EAST BASIN MODIFICATIONS ON LOT 2 OF SCHNUCKS NORTH SUBDIVISION

SUPPLEMENTAL INFORMATION

SCHNUCKS NORTH-EASE BASIN REVISION

RE: Schnucks North East Basin Revisions
Lochgroup No. 107-0141-HPD

SHEET TITLE:
LOT 2 WALL PLAN & SECTION

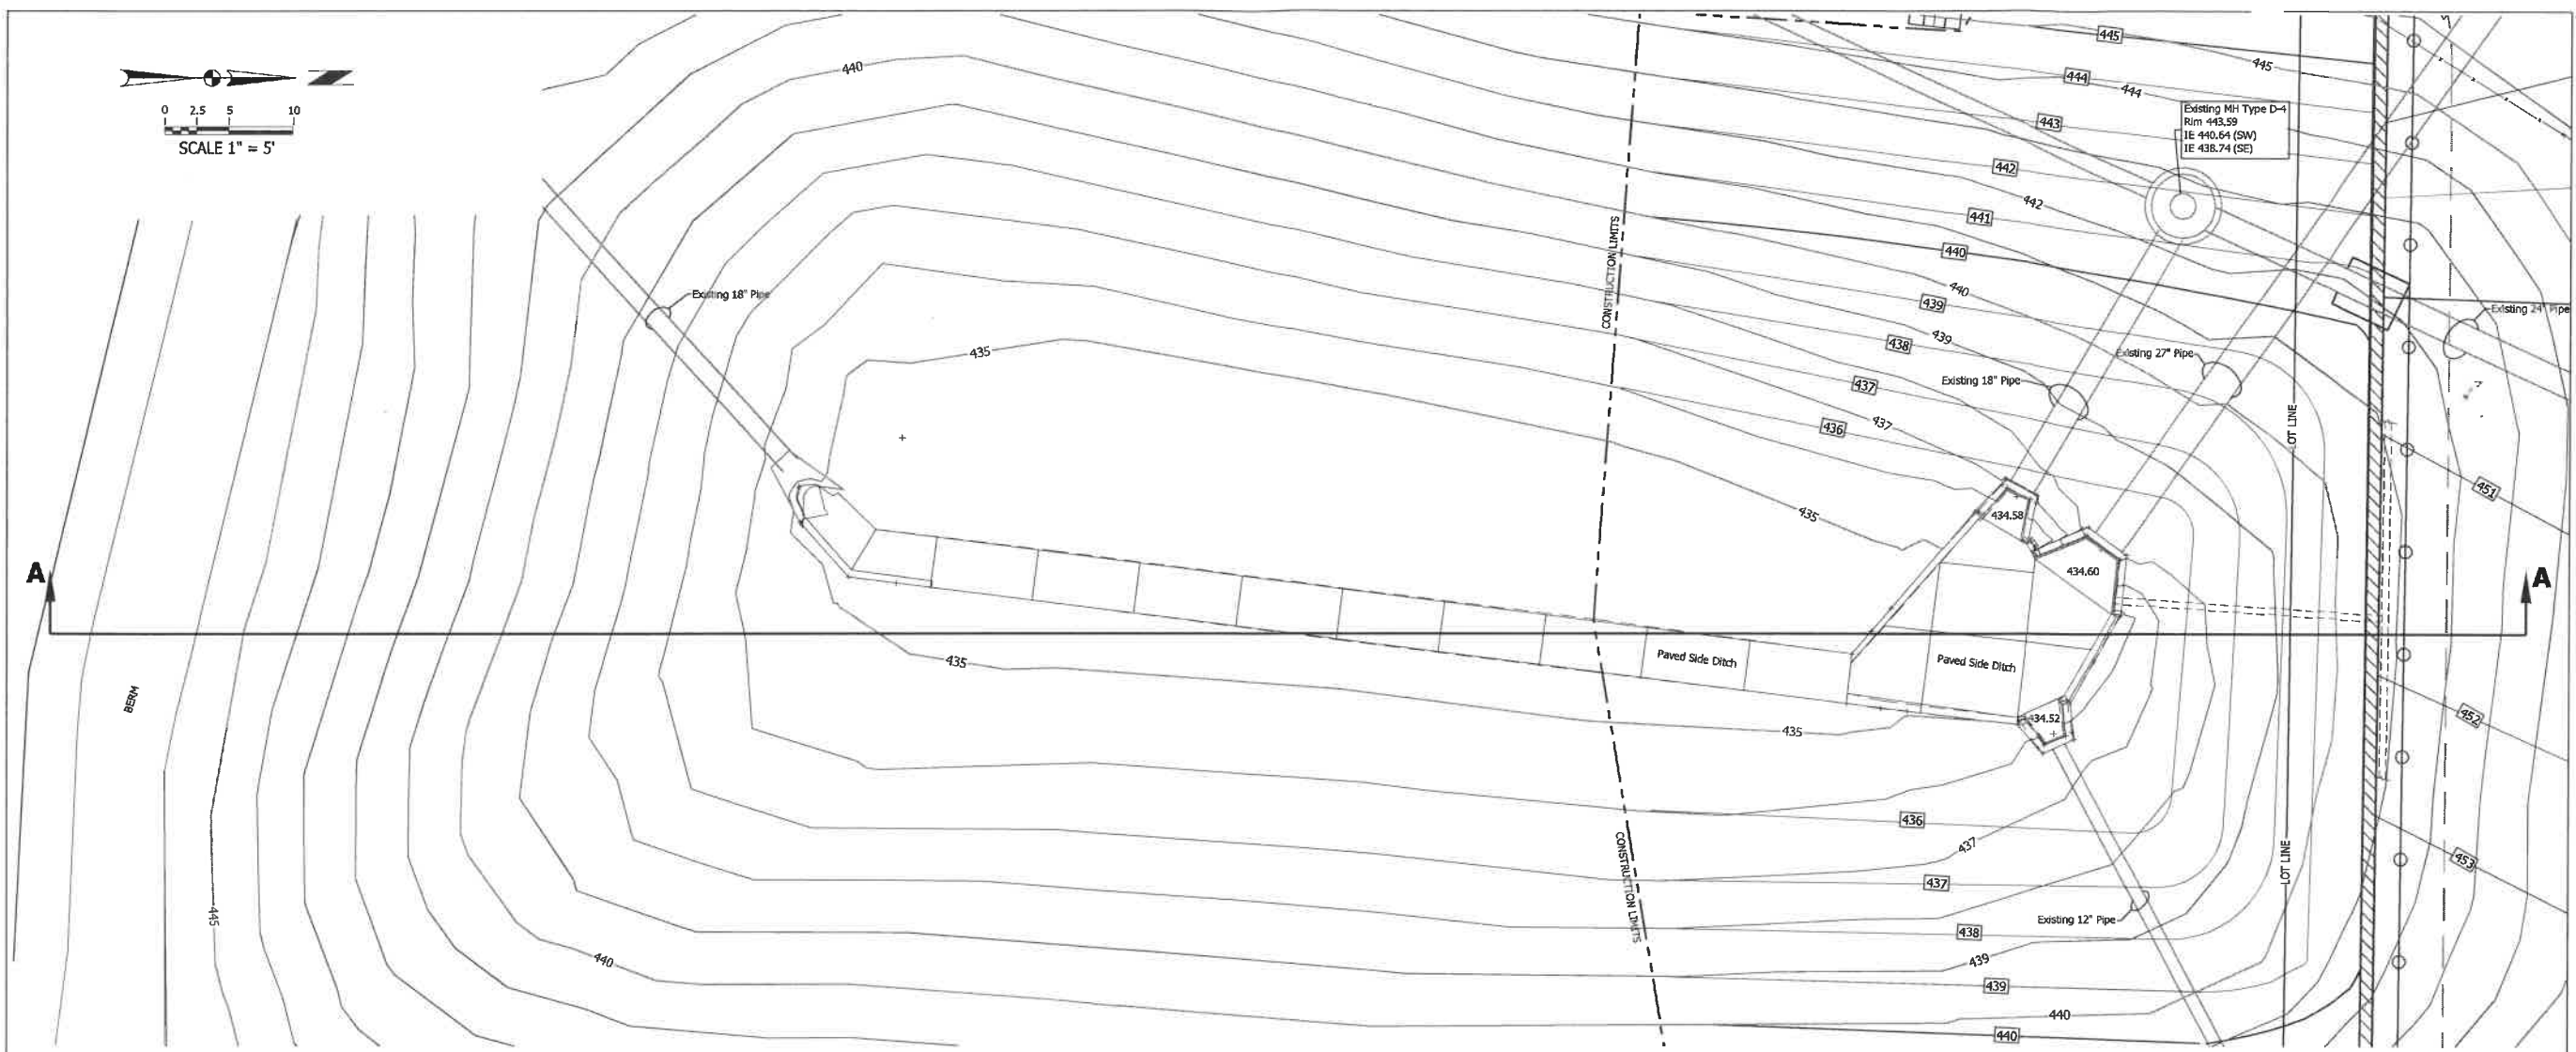
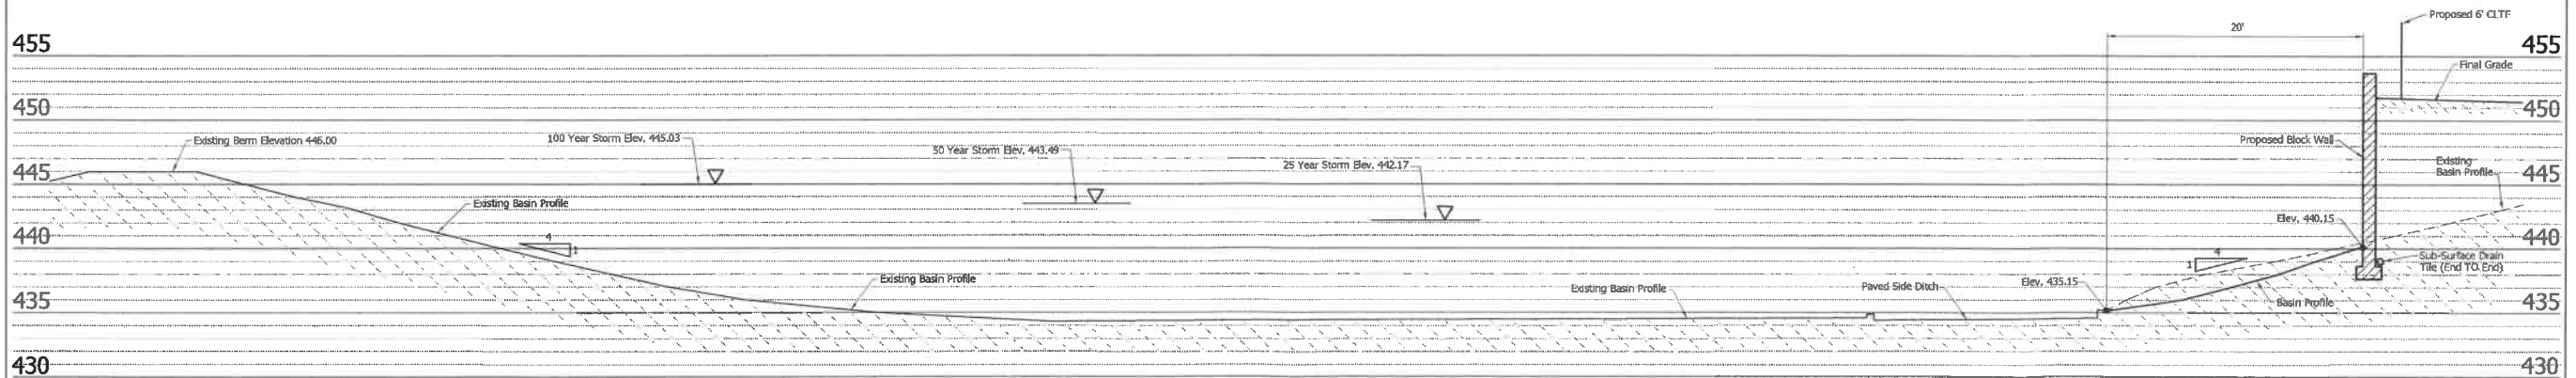
SINGLE North-South cross section needed that shows the following: Current cross section, alterations to north end (cut out of bottom, wall and filled material), pool elevation at 100 year storm (445.03) and elevation of emergency spillway (445.5), location of 20' drainage easement as it exists on north end and proposed drainage easement line **Provided**

SINGLE North-South cross section needed that shows the following: Current cross section, alterations to north end (cut out of bottom, wall and filled material), pool elevation at 100 year storm (445.03) and elevation of emergency spillway (445.5), location of 20' drainage easement as it exists on north end and proposed drainage easement line - see attached Appendix A-3 Lots 2 Wall Plan & Section.

DRAINAGE EASEMENT VACATION

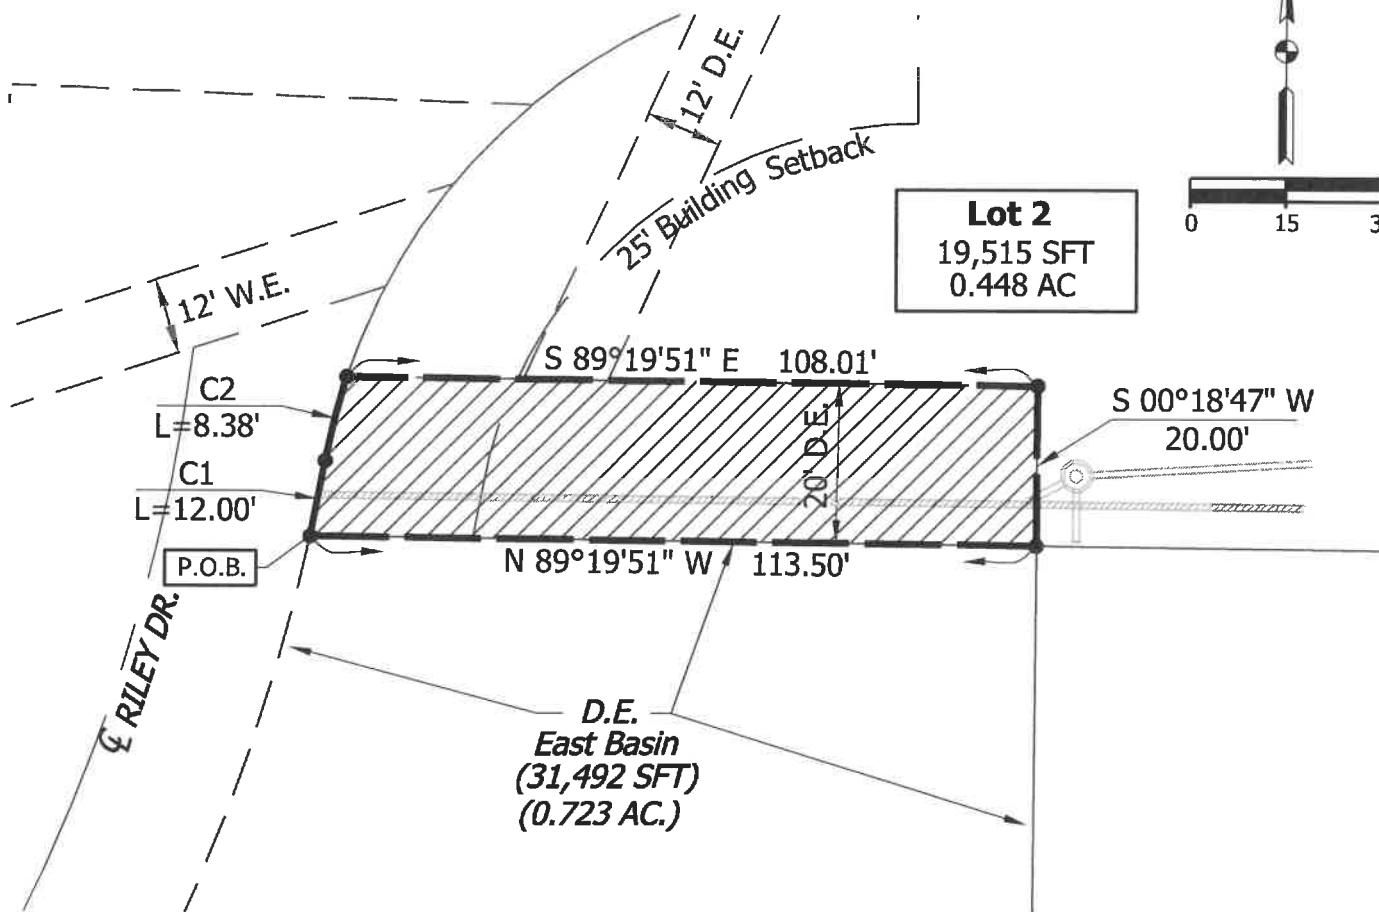
An additional inlet and pipe are shown to be added. This needs to be shown on a proposed easement, which will need to be recorded. Recording of this easement will be a condition of approval and will be required to be completed prior to any sign off on the development of the lot.

- see attached Vacation of Drainage Easement Description with Exhibit Drawing and Proposed Drainage Easement with Exhibit Drawing.

PROPOSED DRAINAGE EASEMENT

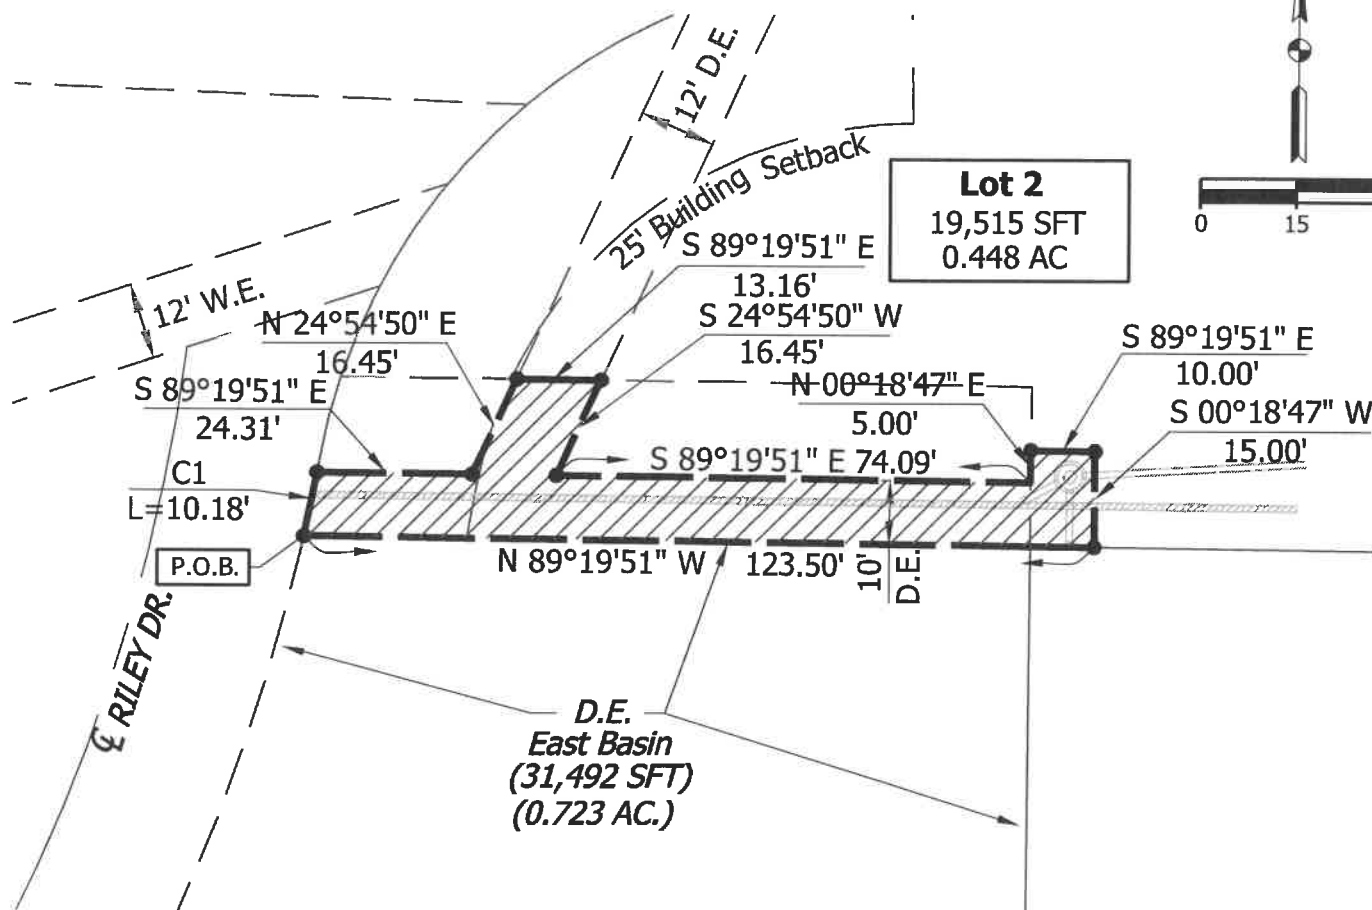
An additional inlet and pipe are shown to be added. This needs to be shown on a proposed easement, which will need to be recorded. Recording of this easement will be a condition of approval and will be required to be completed prior to any sign off on the development of the lot. Provided though additional area will be required-conditional approval will require easement to be recorded prior to modifications to lot 2
